30-045-34002 BISTI GALLUP 20 #009

DJR OPERATING, LLC

Plug and Abandonment Procedure

CONDITIONS OF APPROVAL

Proposed Wellbore P&A Diagram

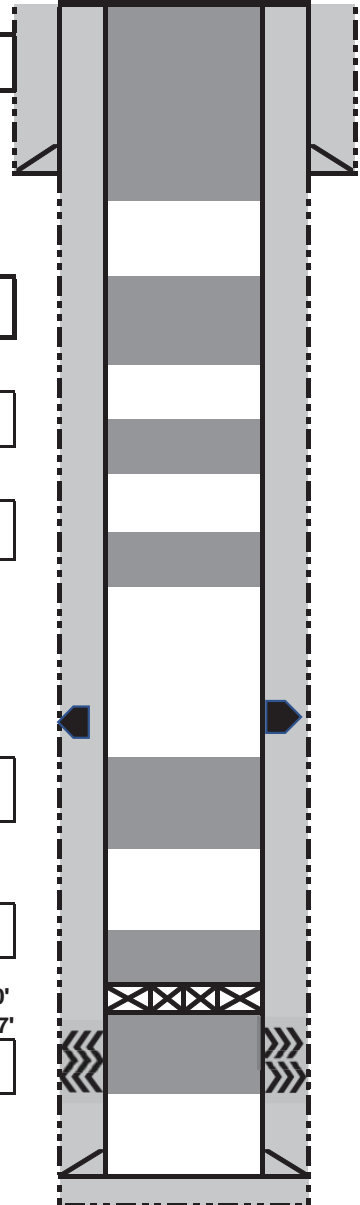
- Notify NMOCD 24 Hours prior to commencing activities
- In addition to the BLM approved plugs:
- Install proposed plug #6 to cover the Fruitland. OCD Fruitland pick @ 840.'

- Please ensure that the tops of the Pictured Cliffs and Fruitland formations, as well as the entire Ojo Alamo aquifer, identified in this report, are isolated by proper placement of cement plugs. This will protect the freshwater sands in this well bore.

- Please note that the BLM geologist's pick for the Cliff House formation varies significantly from the operator's pick. In addition, the top of the Menefee formation varies slightly from the operator's pick and the Menefee is encountered twice, above and below the Cliff House.

1. Plugging operations authorized are subject to the attached "General Requirements for Permanent Abandonment of Wells on Federal and Indian Lease."
2. Farmington Office is to be notified at least 24 hours before the plugging operations commence (505) 564-7750.
3. BLM tops are based on the attached geologic report. Ensure all plugs cover 50 feet above and below indicated formation tops with plugs meeting General requirements. Minimum inside plug to include 50' excess cement. Minimum inside plug 18 sacks class g cement. See attached BLM geologic report.
 - a. BLM picks Cliffhouse formation top at 1915'. Plug to cover 1965 - 1865.
 - b. BLM picks Fruitland formation top at 735'. Plug to cover 785 - 685.
